[Docket No. 94-NM-28-AD; Amendment 39-9292; AD 95-13-12]

Airworthiness Directives; Boeing Model 767 Series Airplanes Equipped With General Electric CF6-80C2 Series Engines

ACTION: Final rule.

Electro-Mechanical Brake and CDU Cone Brake Torque Check
Figure 1

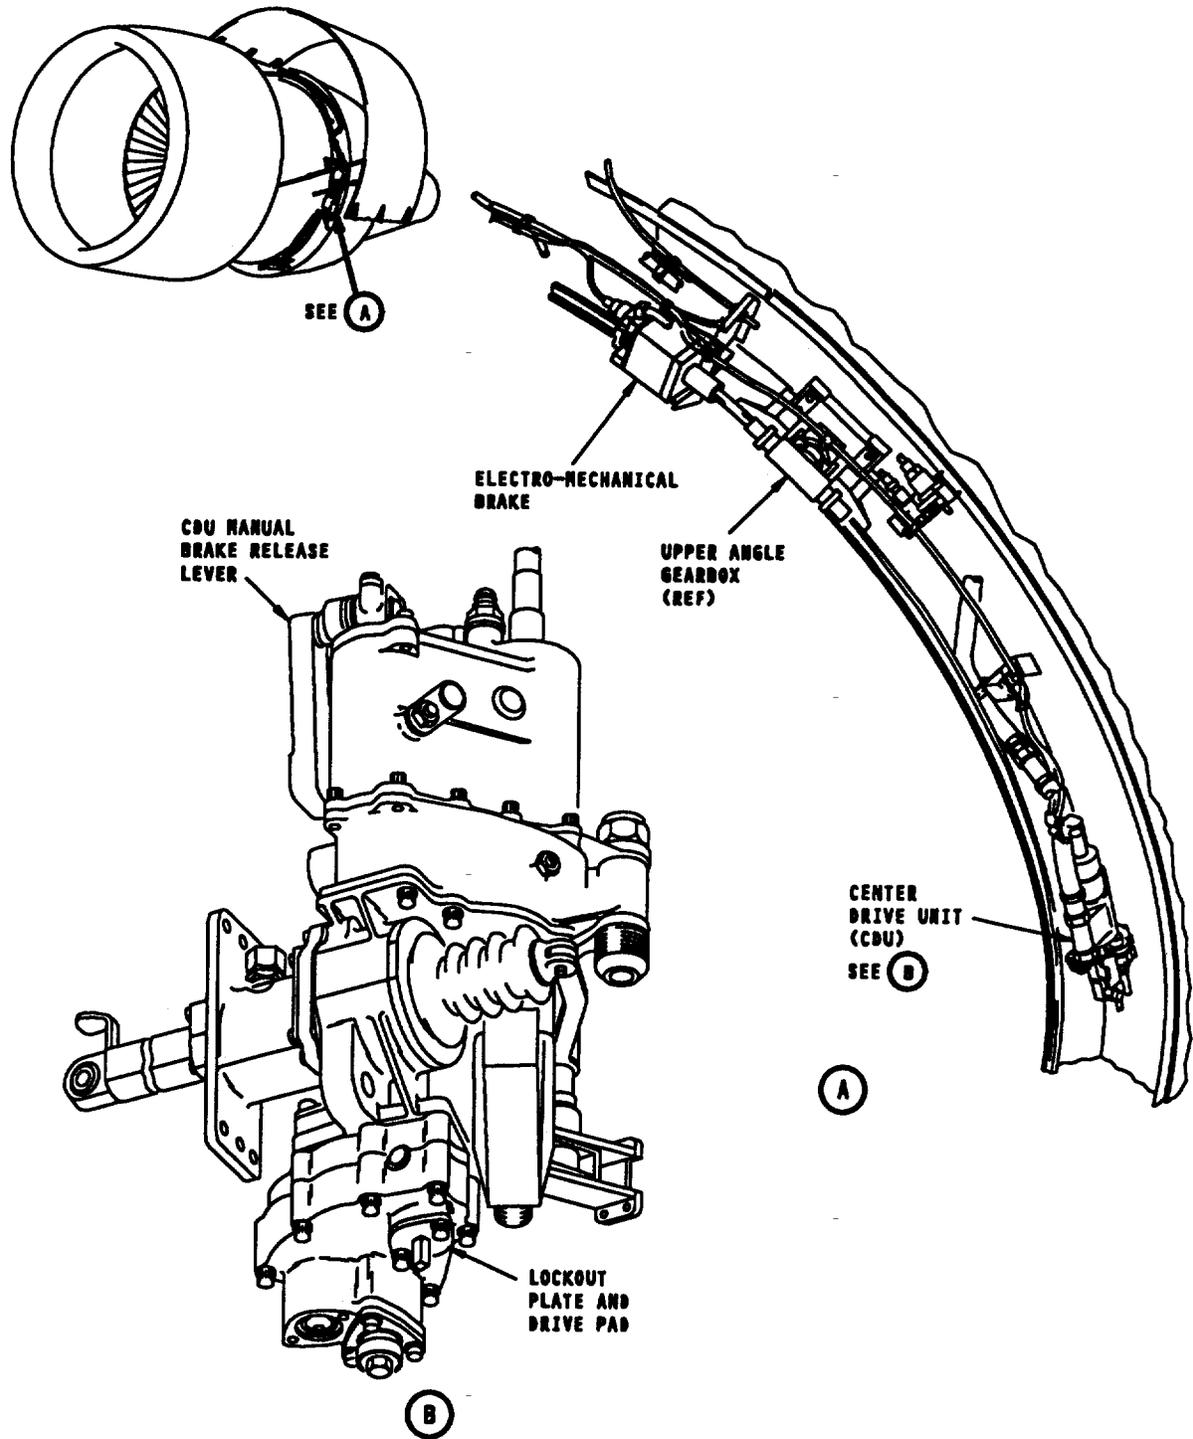
One commenter requests that the proposed compliance time for installation of the terminating modification be extended from 3 to 5 years to be consistent with similar rules that are applicable to Boeing Model 767-200 and 757 series airplanes. The FAA does not concur with the commenter's request to extend the compliance time. In developing an appropriate compliance time for installation of the terminating modification on the affected airplanes, the FAA considered operator fleet sizes,

One commenter requests that the work hour estimate specified in the proposal for installation of the terminating modification be increased from 786 to 880 work hours. Based on its experience, the commenter states that 880 work hours represents the actual time required for accomplishment of the terminating modification. The FAA does not concur with the commenter's request to increase the work hour estimate. The appropriate number of work hours necessary to accomplish the required modification, specified as 786 in the economic impact information, below, was provided to the FAA by the manufacturer based on the best data available to date. That estimate represents the time for direct labor only and is based on the assumption that the modification will be performed by an experienced maintenance crew. However, in light of crew experience, some variability in the estimated number of work hours is likely to exist from operator to operator.

One commenter indicates that a re-identification table provided in Revision 3 of General Electric Service Bulletin 78-135 contains numerous part number errors that should be corrected before a final rule is issued. (The General Electric service bulletin is referenced in "NOTE 2" of the proposal as an additional source of service information for installation of the terminating modification.) The FAA infers from the commenter's statement that it requests that issuance of the final rule be delayed until General Electric releases a revised service bulletin containing correct part numbers. The FAA does not concur. The FAA has been unable to confirm the future date of issuance of Revision 4 of the General Electric service bulletin. In

2. Electro-Mechanical Brake and CDU Cone Brake Torque Check (Fig. 1)

(e) Apply 90 pound-inches of torque to the system.

(1) The electro-mechanical brake system is working correctly if the torque is reached before you turn the wrench 450 degrees (1-1/4 turns).

(2) If the flexshaft turns more than 450 degrees before you reach the specified torque, you must replace the long flexshaft between the CDU and the upper angle gearbox.

(3) If you do not get 90 pound-inches of torque, you must replace the electro-mechanical brake.

(1) If the wrench does not return to within 30 degrees of initial starting point, you must replace the long flexshaft between the CDU and upper angle gearbox.

(6) Turn the torque wrench to try to manually extend the translating cowl until you get at least 15 pound-inches.

(a) If the torque is less than 15 pound-inches, you must replace the CDU.
